## Response to Castle Adequacy Review Response #3

## Memo

**Re:** Continental Materials Corporation/Castle Aggregate, Pikeview Quarry, Permit M-1977-211, Amendment 04, Review of February 7, 2020 Operator Adequacy Answer to DRMS Third Adequacy Review and DRMS Fourth Adequacy Review.

Figure 1. From Google Earth aerial photo of June 6, 2018 showing informal upland drainage ditch breached in approximately 2015 and still not repaired as of 2018. Above west quarry highwall, north side.

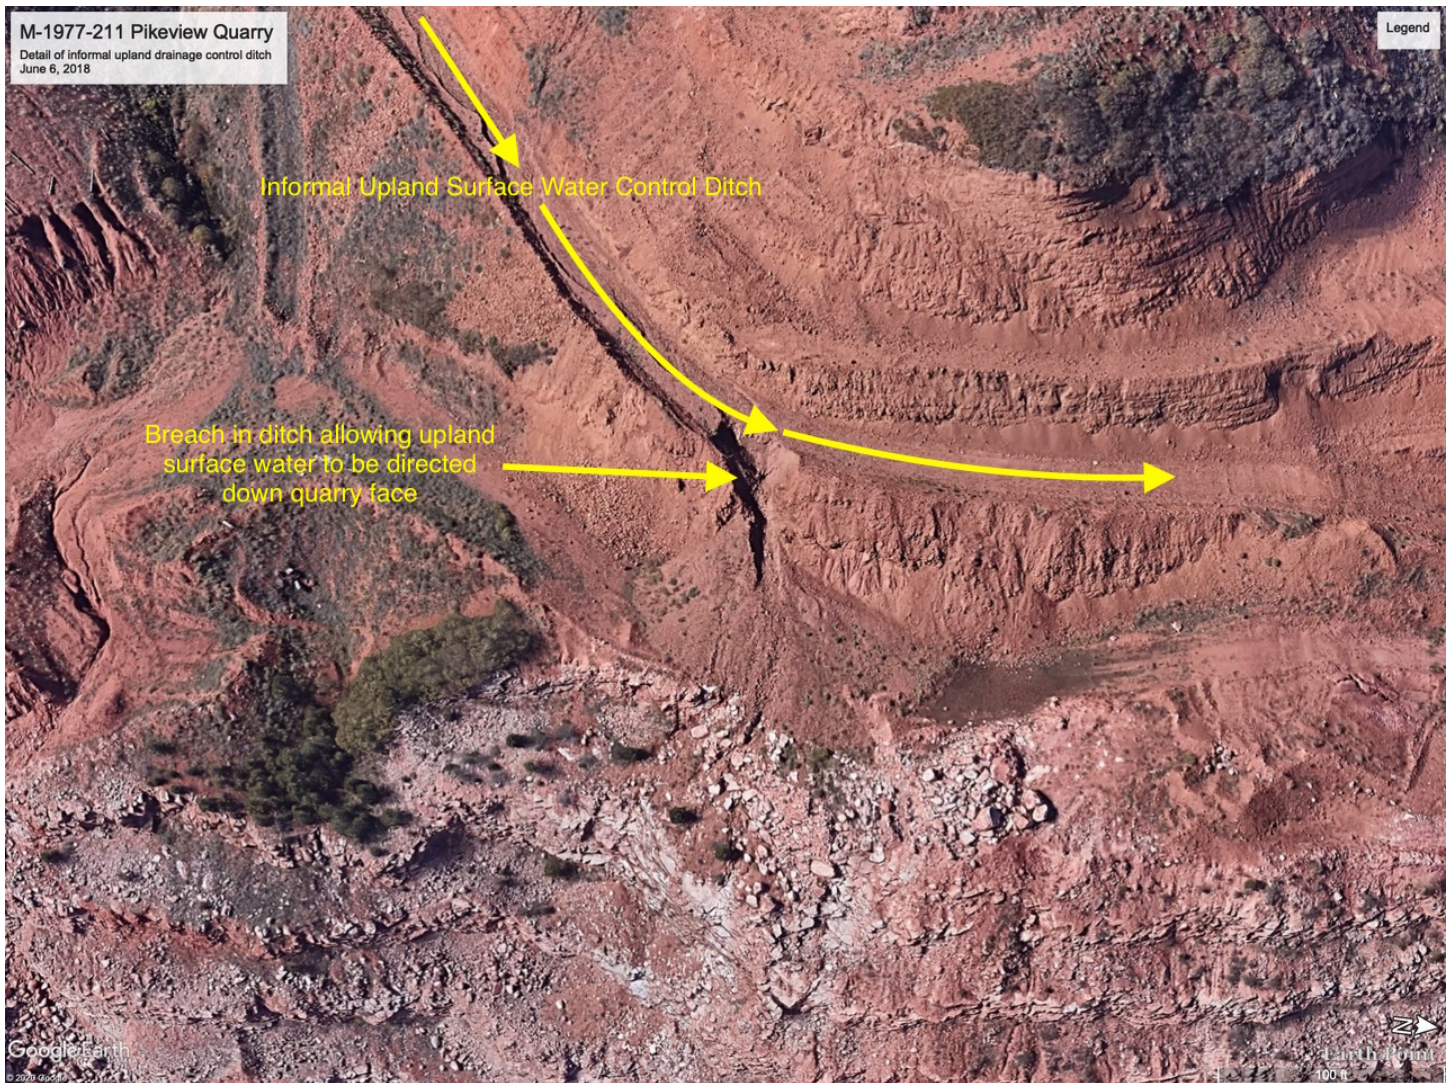
CMC Response to question 33g relating to stormwater diversion during reclamation is the same CMC proposed solution that has not worked before. CMC is counting on “existing diversions” that have failed in the past. The DRMS Fourth Adequacy Review letter says that this response is adequate.

The failure of the northern diversion is what caused water to cascade down the quarry wall in 2015. This ditch looks like it is still not repaired as of 2018 (see Figure 1). It is now obvious that this approach leads to consistent failure of the upland diversion ditches. Why is DRMS not requiring designs for this structure at this point and requirements that the structure be built to those designs?

Figure 4 – Pikeview Quarry – Detail of conchoidal fractures in the south part of the West Highwall, 2018.

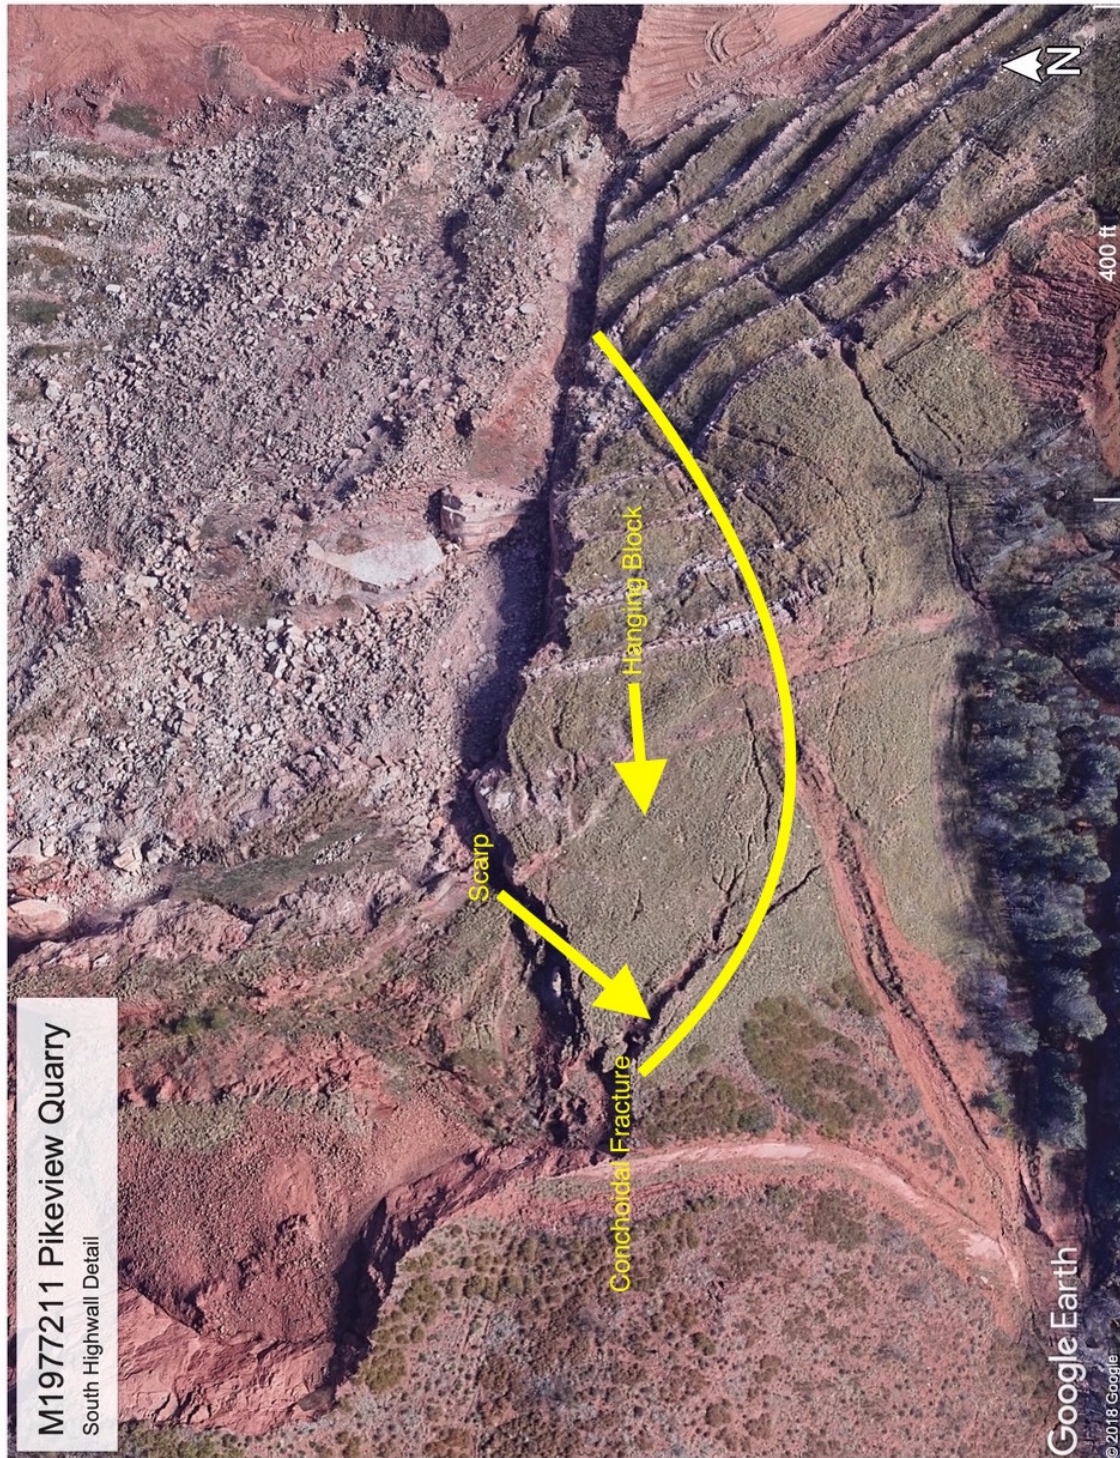
Aerial photos of 2017 (Figure 2) and 2018 (Figure 3 - whole quarry; Figures 4 and 5 - detail) indicate a scarp above the southernmost hanging block at the top of the highwall. The Sawatch clay layer underlies the hanging block located on the south side of the western highwall. Exponent deemed the clay layer the primary failure cause for the December 2, 2008 and related slides. In other words, we are not talking about safety factors of unconsolidated materials such as exist in the body of already failed material but a special condition of a clay layer in the upper part of the Sawatch Formation that could lead to sudden and unexpected sliding of now hanging material above that layer now that the buttressing blocks of material below this have already failed and slid downslope. An additional complicating and destabilizing factor is that the scarp and the separation of materials at the top of the block will probably allow additional surface water to flow directly to the clay layer and further lubricate and destabilize this block.

Figure 5. Oblique aerial photo from Google Earth showing detail of south most hanging block at top of west highwall. Scarp above block and block noted by arrows and conchoidal fracture denoted by line.

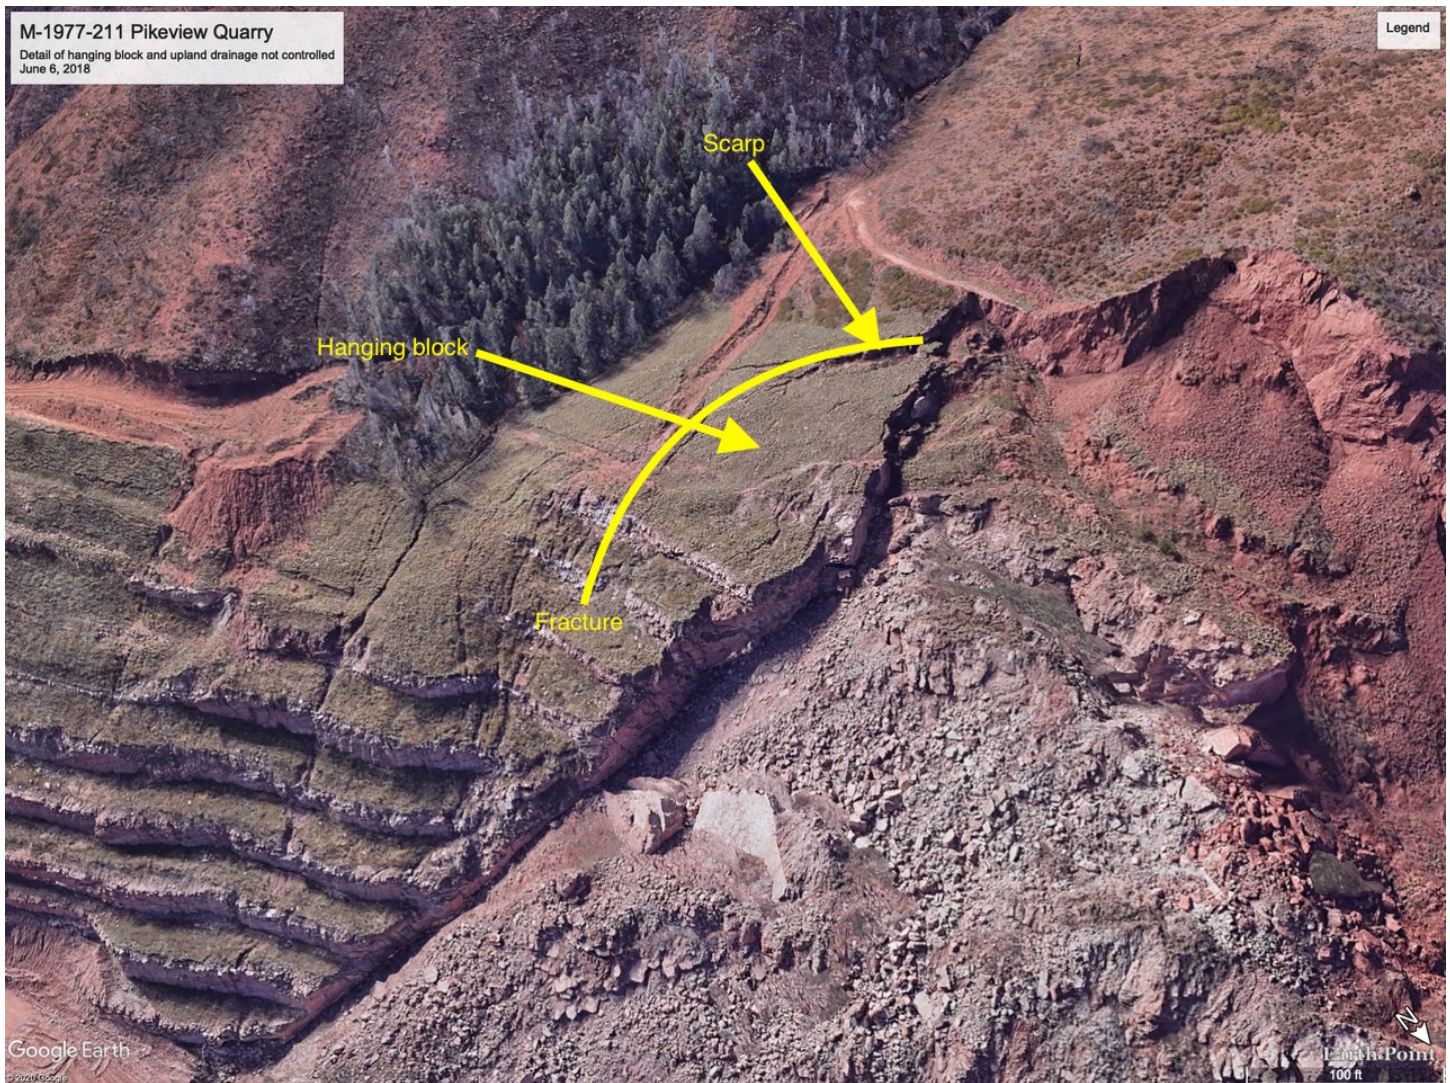
One of the ways to determine whether this block is presently moving is for CMC to produce long-term prism monitoring data for the possible hanging block of limestone material (prisms P66, P70, T1). DRMS must request that CMC produce this data to ensure worker safety and/or unnecessary problems that will not be covered by the reclamation bond.

Figure 7 – From Exponent Report (2011), Appendix 39. Cross Section G-G' showing limestone hanging block on top of clay layer that was the primary cause of the December 2, 2008 slide and subsequent slides.

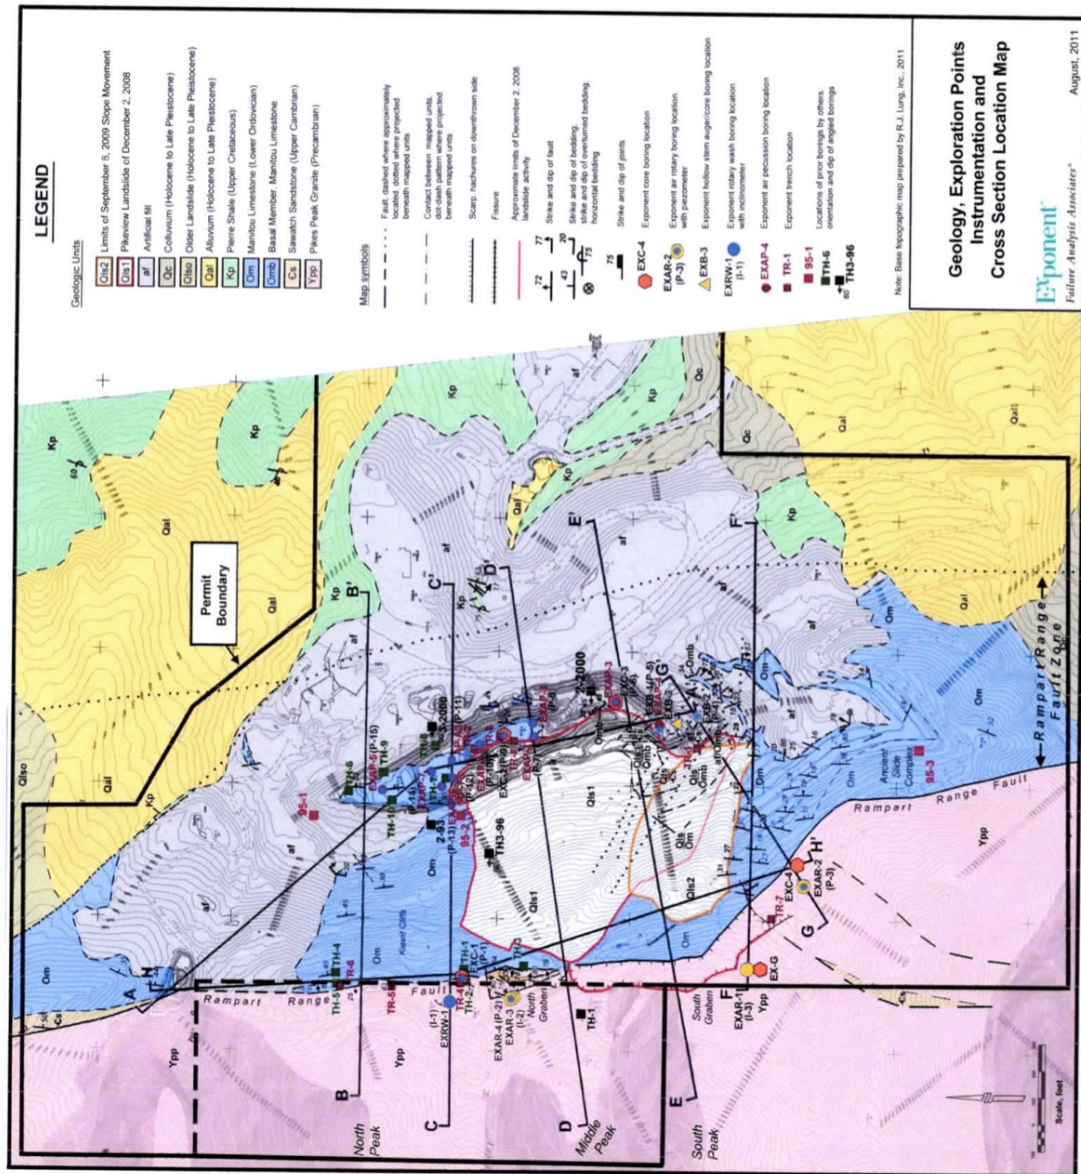
The Exponent Report of 2011 includes a cross-section in Appendix 39 (G-G') that is indeed drawn along the slope gradient and probably intersects part of the present hanging block of limestone in the southern part of the west highwall of the quarry (Figures 6 and 7). After reading this part of the Exponent Report, the concern of instability of this rather large block of material only grows larger because it clearly shows that this is a hanging block and the block could slide in the near future if not properly buttressed, avoided, or handled in some other appropriate way. CMC and DRMS need to recognize this to protect worker safety and address this concern.
